Development Application DA 2020/0068

9 and 10, Surfside Avenue, Avalon

View sharing assessment

Report prepared for: L and R Seeto by Dr Richard Lamb February 2020

Figure 1;

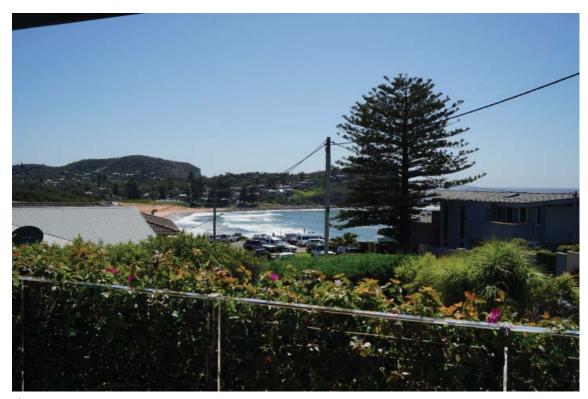
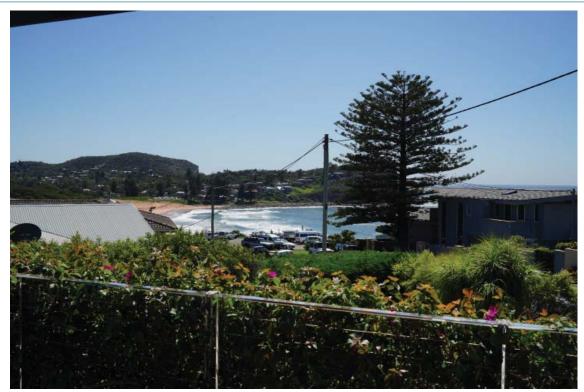
A real photograph showing the view from the south end of the balcony in the approximate location simulated in the CGI is attached (Figure 1). I established that even using a wide angle lens with a focal length of 24mm (see Figure 1), I was unable to encompass the horizontal field of view in the architect's CGIs. The computer's theoretical camera used to prepare the CGIs is therefore showing a field of view that is unrealistically wide and the items in the view that are smaller than in reality. The CGI also incorrectly predicts that the beach is essentially absent from the existing view.

A photograph taken from the same location as the CGI, using a 35mm lens, is attached as Figure 2. This lens gives a reasonable representation of the field of view available to the eye and of the relative size of items in the view. Note for example, that in the CGI, there is a house visible on

the right across the road, which is not in the 35mm image at all. In addition, the south wing hip of the roof on the house at 9 Surfside Avenue is visible in the CGI, but is only partly visible in the photograph.

It shows that the roof of the south pavilion in the proposed development blocks the view of the beach at north Avalon almost entirely and also impacts on the wave zone. Both the front and side setback and the overall height of the south pavilion are causes of view loss, as well as the length of the cantilevered roof that projects toward the street. The view lost is of highly valued items identified in Step 1 of *Tenacity* (see assessment below). The sloping surface of the roof is to be occupied by photovoltaic cells, that slope downward toward the viewer and are viewed from the south. There may be significant glare and reflection of light into my client's property.

In my opinion the answer to the skillful design question is in the affirmative. A more skillful design is required, which is capable of providing more satisfactory view sharing by increasing both the south and front setbacks of the south pavilion so as to move the bulk of the building backward and away for the boundary, reducing the extent of the overhanging balcony roof to the street and decreasing the bulk and height of the south pavilion, to retain a view of the beach as is currently available. Given the size of the site and the low site coverage proposed, it is clearly possible to redistribute the footprint and revise the height and bulk of the south pavilion in the foreground of the views from my clients' dwelling, without affecting the development potential of the site, at the same time achieving a better view sharing outcome, that is reasonable.
